भूगर्भ निरीक्षण आख्या जी० पौ० 203 सड़क समरेखण/पुल/गढ़वाल क्षेत्र/उत्तराखण्ड

Geological assessment of the alignment corridor proposed for the construction of 4.650 km long motor road joining village Morivana to Manjket lies at km 10 of Laluri-Koti-Mehro ki Manjket motor road, in Thauldhar block, dist. Tehri Garhwal

01 जून 2025

Google earth image showing proposed alignment joining village Moriyana to Manikhet lies at km 10 of Laluri-Koti-Mehro ki Manikhet motor road, in Thauldhar block, dist. Tehri Garhwal.

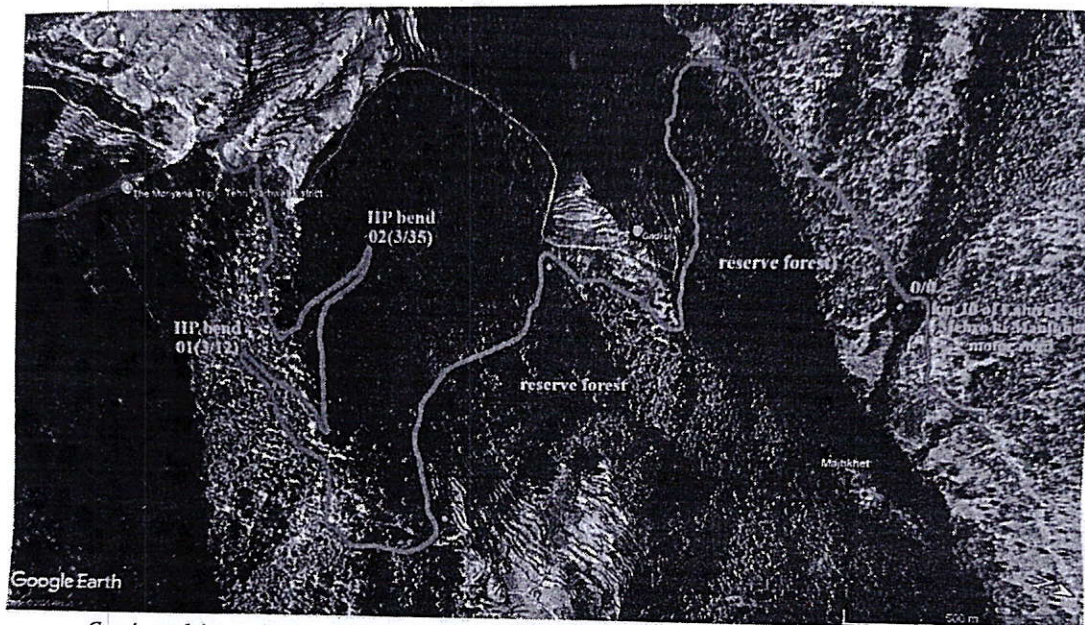
The proposed alignment connects the population of village Moriyana where the arms are falling one above the another with thick overburden across the gentle

hill slope. The hill slope have scattered large boulders signifying chronic landslide which attains its dormant stage. Dominant stretch passes across the reserve forest and the civil land nearby the villages. The phyllite rock is argillaceous in nature which is highly porous and low/no permeability. The phyllites with subordinate slates is slightly weathered and oxidized (W_2 to W_3 weathering Grade) in nature. These are thinly foliated, hard and compact in nature and exhibitors fair values of physical competence. According to the estimation made at the site the "Uniaxial Comprasive Strength" of the bed rocks were found ranging between 30 M Pa to 50 M Pa. The Rock Quality Designation (RQD) values of the phyllites exposed along this alignment corridor determined manually at the site was calculated ranging between 20% to 30%, hence these the phyllites falls in the Rock Class-III (Fair) as per Rock Mass Rating. It has been observed that the soils forming the slopes contain clay minerals in abundance with thick pine vegetation therefore these may exhibit contrast values of strength under the dry and wet conditions. According to the assessment made at the site the "Undrained Shear Strength" of the soils exposed along this corridor was found ranging between 300k Pa to 400k Pa and the "Uniaxial Compressive Strength" of the rock masses was found ranging between 30 M Pa to 60 M Pa. It has been observed that most of these soils are generated by the decomposition of terrain rock, therefore these are residual soils and contains plastic clay minerals in abundance.

By and large, the alignment slopes are stable and presently free from any landslide/ mass wasting activities but due to the massive dolomitic terrain where the probability of sink holes/pot holes/caves formed due to dissolution action of carbonate rock.

- a. The work of road cutting can be carried out by bench like cutting full excavation method.
- b. Blasting is strictly prohibited considering loose rock mass along the alignment and dense population close to the proposed alignment.

- c. Do not throw the excavated waste on the lower hill slope otherwise which may damage the cultivated land of the local villagers. Dumping should be only be carried out at dumping yard proposed before cutting of road.

- d. In order to maintain the overall stability of the hill slopes and the road, construct suitably designed retaining walls/ breast walls along the road, wherever required.

- e. Construct large hill side lined/concrete drain all along the road and make adequate cross drainage arrangements.
- f. Make adequate arrangements to dispose the waste water on the safe/ stable ground.
